Exhibit F	Dr. Evan Dethier, Review of Erosion in the Turners Falls Impoundment (May 19, 2024)
Exhibit G	Connecticut River Conservancy letter to Secretary Bethany Card at the Executive Office of Energy and Environmental Affairs, Re: Turners Falls Hydroelectric Project, et al. under P-1889, et.al., FERC Relicensing and Massachusetts Clean Water Act § 401 Certification (June 13, 2022)

Re: Offer of Partial Settlement; Turners Falls Hydroelectric Project (FERC No. 1889-081) and
Northfield Mountain Pumped Storage Project (FERC No. 2485-063)

**COMMENTS OF THE CONNECTICUT RIVER CONSERVANCY
IN OPPOSITION TO OFFER OF SETTLEMENT**

Figure 1. Relicensing Study 3.3.1, Figure 5.3.2-1

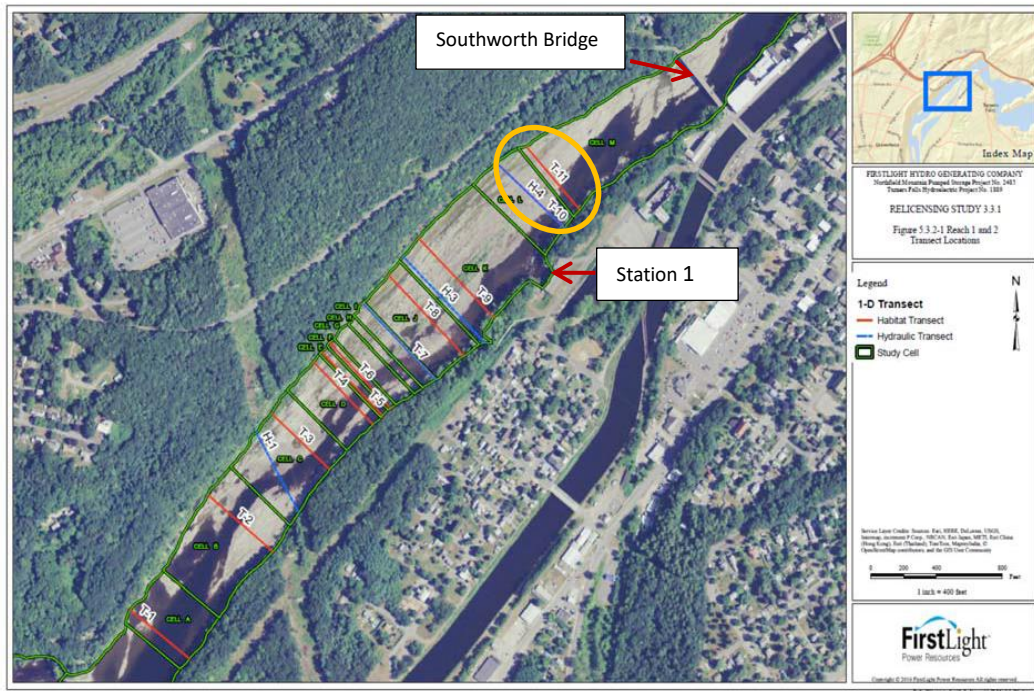
10. Study 3.3.1 analyzed transects 10 and 11 for habitat (WUA) in Reach 1 of the “bypass channel” below the immediate area of the dam. Figure 1, below, shows the area of the transect analysis.

Figure 2. CRC letter dated June 13, 2022 to Secretary Bethany Card, Massachusetts Executive Office of Energy and Environmental Affairs.

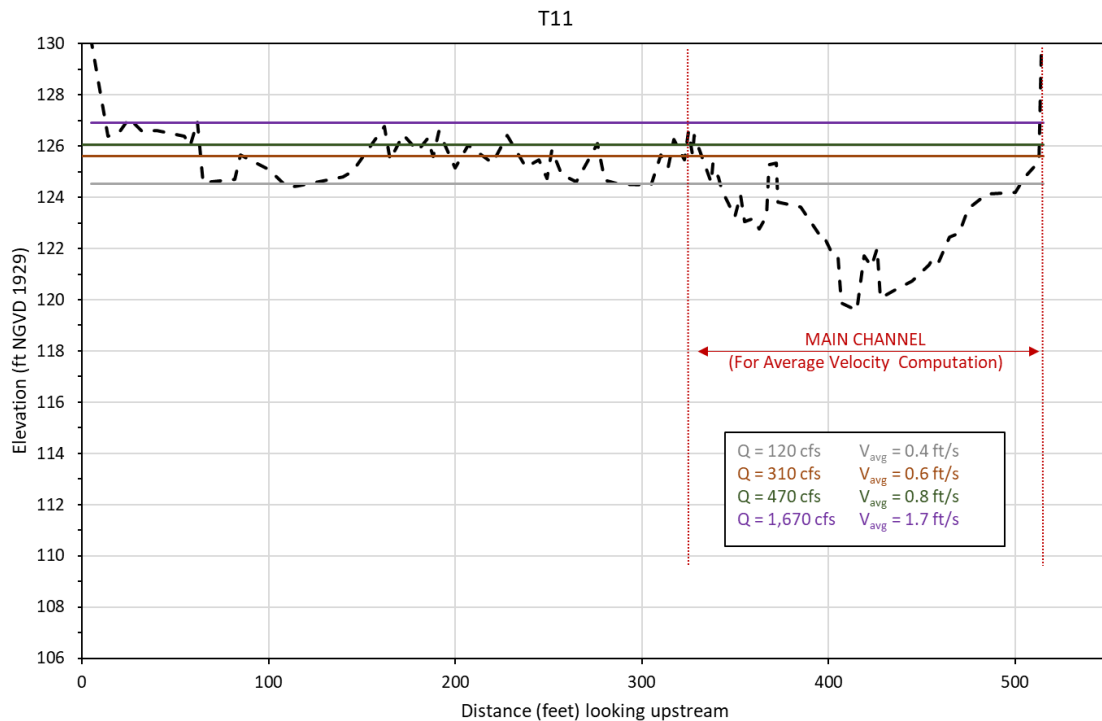
15. Water levels at Transect 11 are shown for four flows in Figure 2 below. At 470 cfs (green line) approximately 35% of the transect is either dry or minimally wetted. At 1,670 cfs (purple line) the full river width is wetted increasing habitat for juvenile fish and macroinvertebrates. Based on the slope of the vertical right bank and near vertical left bank, a flow of 1,400 cfs would closely resemble that of 1,670 cfs (purple line).²

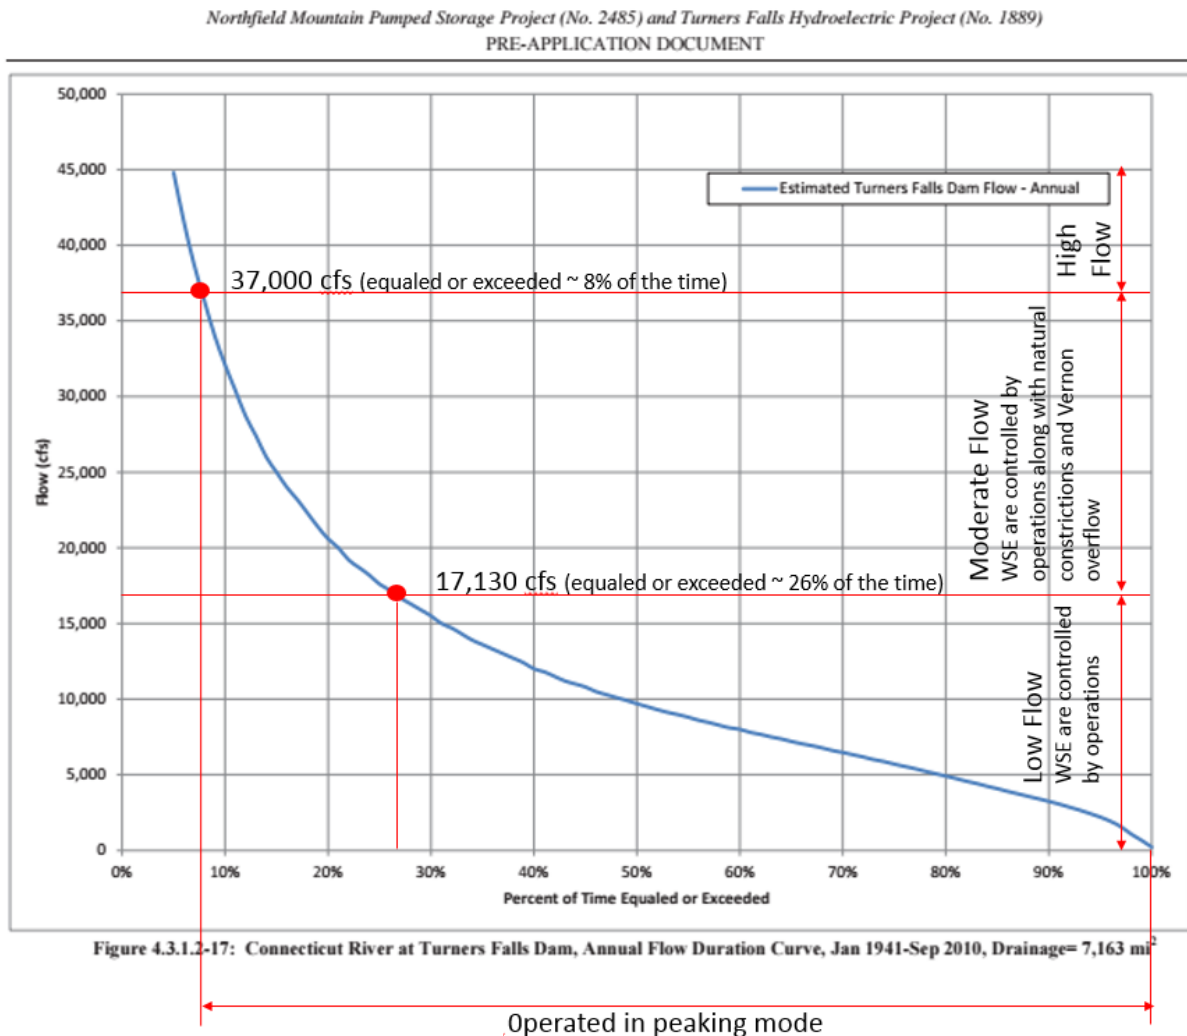
We do not agree with the determination that operations only impact the reach in which they have been allotted to in the Relicensing Study 3.1.2 (i.e. TF to Reach 1, NFM to Reach 2, and Vernon to Reach 4). The Energy Grade Line (EGL) approach described appears to only apply when looking at impacts associated with high flow (>37,000) where the 1-dimensional velocity and sheer stresses determined through HEC-RAS play a dominant role in erosion. The report is clear that for flows below 37,000 cfs (moderate and low flows as per their definition), which occur over 90% of the time according to Figure 4.3.1.2-17 from the October 30, 2012, PRE-APPLICATION DOCUMENT (see figure that follows), the hydroelectric operations of Turners Falls and Northfield Mountain are both controlling factors for the WSE elevation fluctuation throughout the entire TFI, and that for flows below 17,130 cfs, Turners Falls, Northfield Mountain, and Vernon operations are the dominant influence controlling WSE fluctuation throughout the entire TFI. The analysis should not be limited based on hydraulic reaches that only seem applicable for high flows when over 90% of the time the flows in the TFI are lower than the defined high flow, and almost all of the WSE fluctuation caused by the combined hydropower operations is happening below the defined high flow, which is only equaled or exceeded less than 10% of the time.

Figure 5. A plot of modeled water surface elevation from Study 3.1.2⁷⁰ shows up to 6 feet of elevation variation in an approximately weeklong stretch, with similar elevation differences at several cross-section locations in the reservoir.

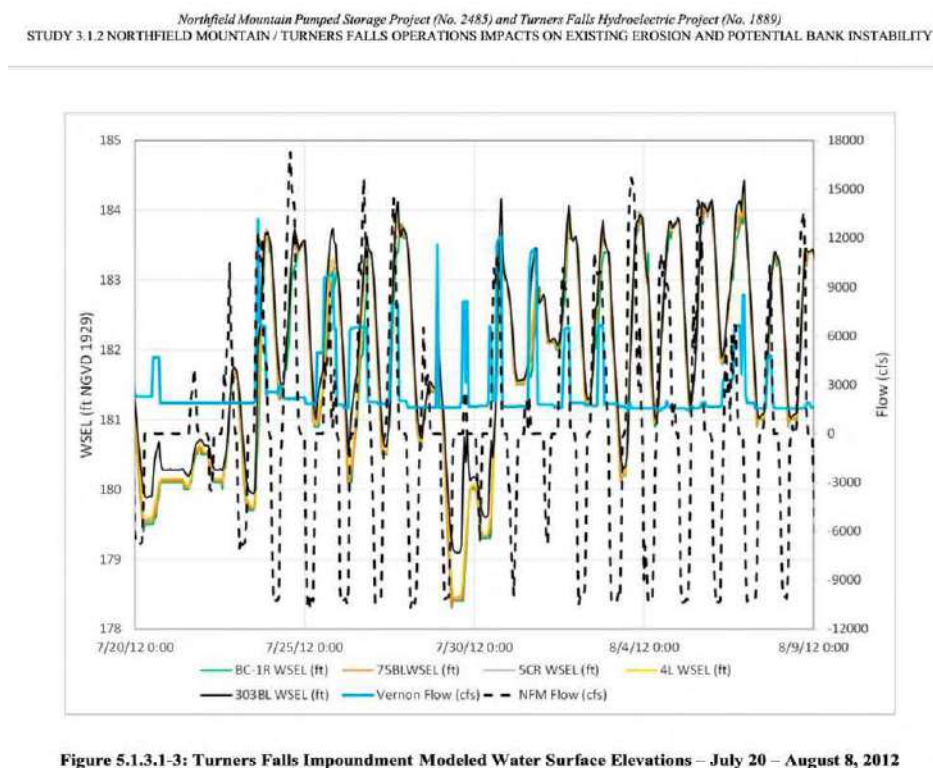
FirstLight claims several times that the upper slopes of river banks are not wetted by their operations, and only experience erosional flows during floods. However, it is clear from FirstLight's reports that Project operations regularly inundate steep banks along the TFI reservoir shoreline. Plots of water surface elevation show as much as 6 ft of daily water surface elevation changes during just one example period⁶⁹. In addition, pumping and release occurs during high-flow events. Fluctuations are thus superimposed on larger fluctuations in the hydrograph, potentially amplifying the erosional effects of those events (Figure 1, Figure 5).

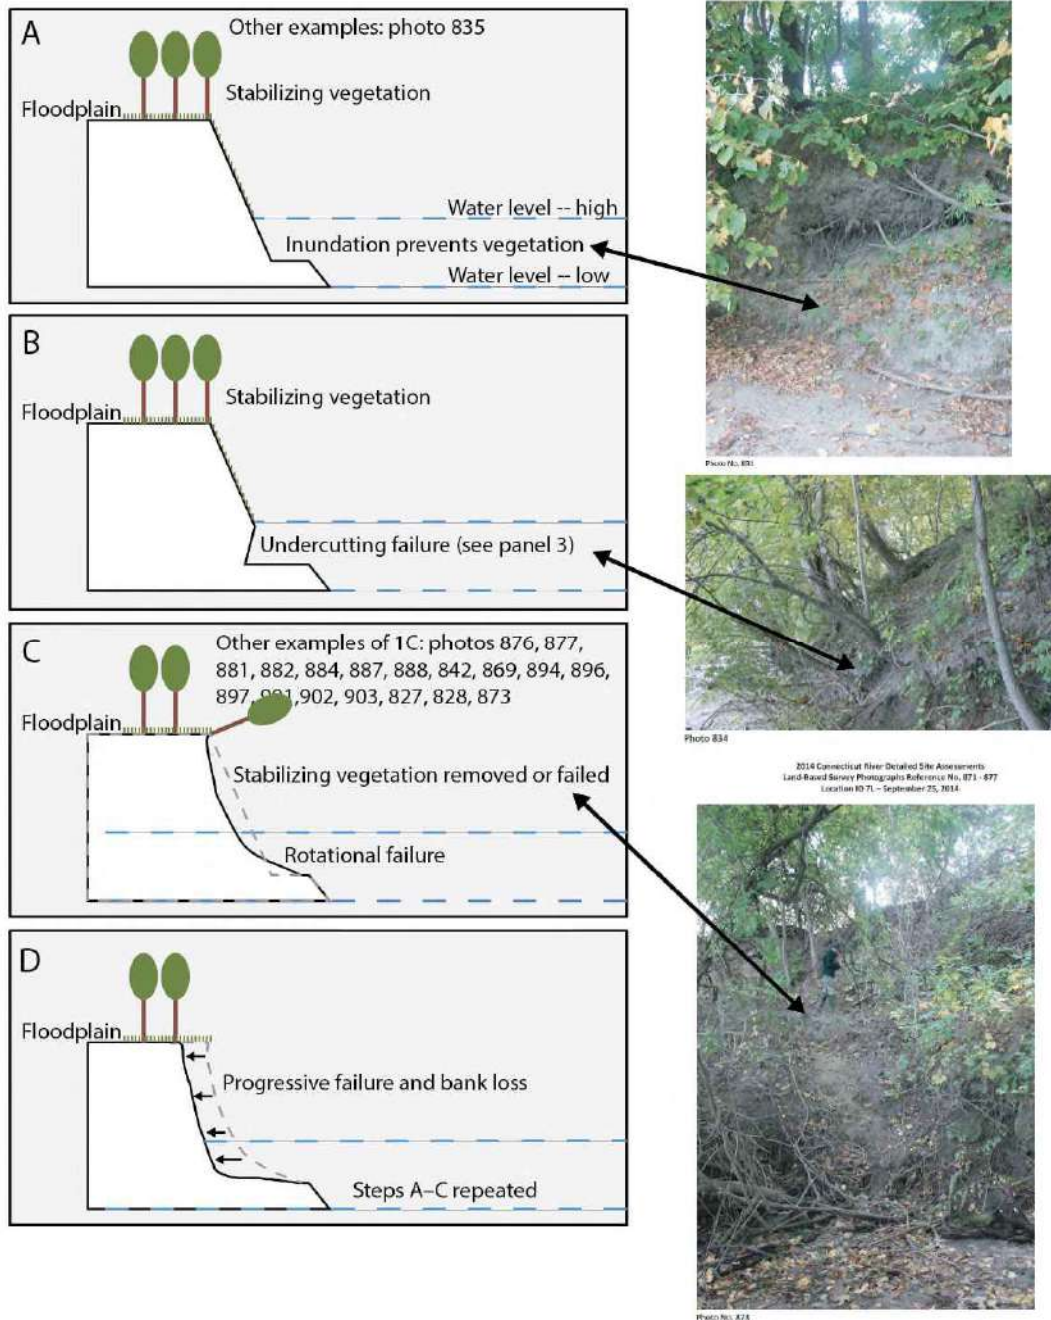
Figure 6 illustrates a sequence of bank undercutting that is likely accentuated by Project operations continually fluctuating water levels up and down, saturating the bank sediments and exposing them to currents and wave action (Figure 6, A). Sediment is eroded when water levels are high, transported away from river banks, tree roots, and beaches. When the reservoir level drops, the undercut sediment may also fail as the water's confining pressure is removed. It is also more susceptible to wave and current erosion because it has been saturated. In each case, because sediment buttresses the banks, its removal destabilizes those banks (Figure 6, B). Community members have observed these processes occurring in the reservoir⁷¹:

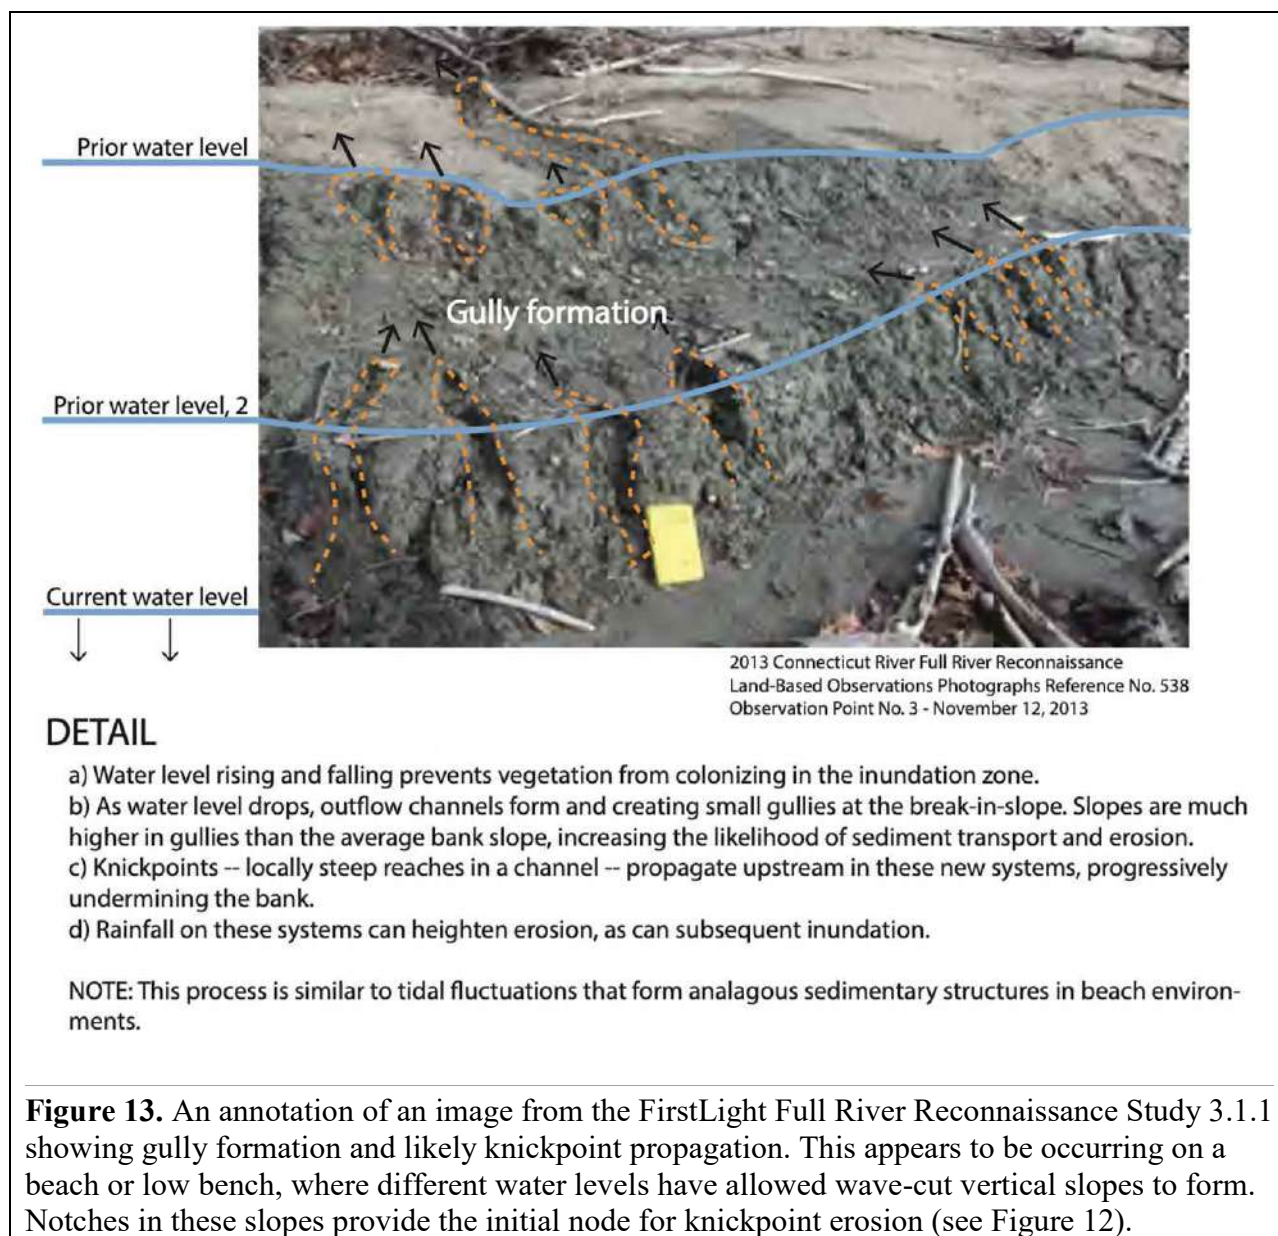
Gullying, rilling, and knickpoint erosion are part of strong erosional feedback loops, as the locally oversteepened point progressively moves uphill, cutting farther into the bank. This process is illustrated in Figure 12 (diagram) and Figure 13 (annotated photograph), which show the process of gully development as it appears to occur along the shoreline of the TFI.

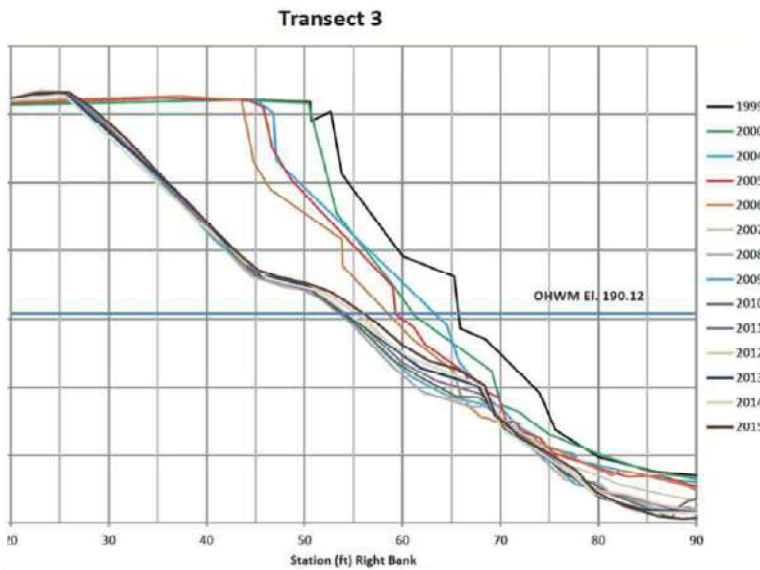
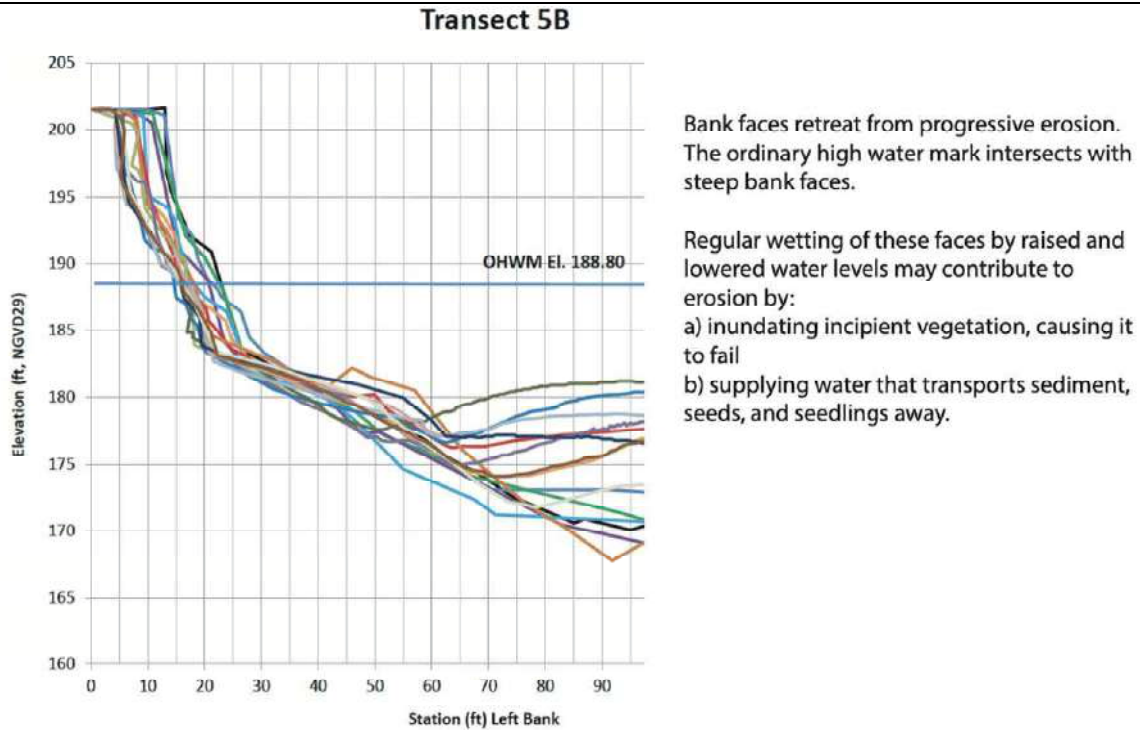
bank is approximately balanced by deposition on the opposite bank or bars. This does not appear to be the case in the TFI, where erosion predominates (Figure 21).
